**Re: Fire Department Building Safety Walkthrough Conducted on June 4, 2018**

### **The City of Mayer Fire Department: 400 Ash Ave N. Mayer, MN 55360**

## Recommendations generated from today's visit:

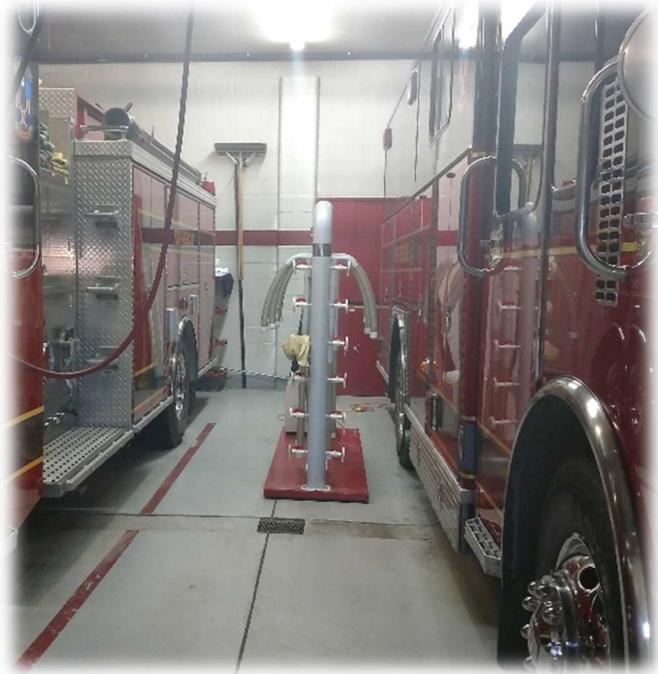
**01-06/18: Recommend reviewing apparatus bays for access and clearance.** The Mayer Fire Department has a very well kept and organized facility including their apparatus bays. All bays have been filled with apparatus, as well as gear lockers, maintenance equipment, and some fire equipment storage.

- Apparatus floor markings help ensure proper location of apparatus to maximize access, and limit hazards. Even with these parking markings, there is limited access at the front and rear of most apparatus for members to walk around apparatus. According to the [Safety and Health Considerations for the Design of Fire and EMS Stations](#) published by the US Fire Administration: Page 67 – A minimum 4-foot clearance shall be maintained (designated) around apparatus parked within the station. Most of the current apparatus do have a 4-foot clearance between. The Front & Rear of almost all apparatus does not meet a 4-foot clearance, with a few less than 2-feet.

- The Fire Service has changed for the better with the introduction of routine PPE Washing, and Maintenance. The Mayer Fire Department have acquired a Gear-Dryer for proper PPE Maintenance and Decontamination. This Gear-Dryer does take up some apparatus floor space, but is a valuable tool for firefighter safety.

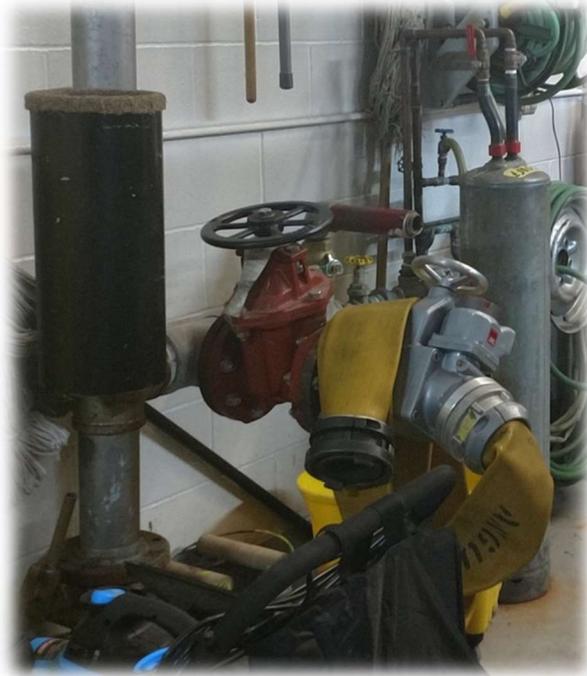
**05-06/18: Recommend reviewing the use of Battery Tenders and Electrical Hazards.** Battery tenders are commonly used for vehicles and equipment that have battery drawdown, and/or that do not get started often. These tenders help maintain the correct voltage to start and operate the apparatus. During the walkthrough the station currently has a couple of Batter Tender Banks mounted to the ceiling and hooked into the electrical system. These tender banks could pose a long-term concern with location, fall hazards, proximity to water, as well as a potential fire hazard.
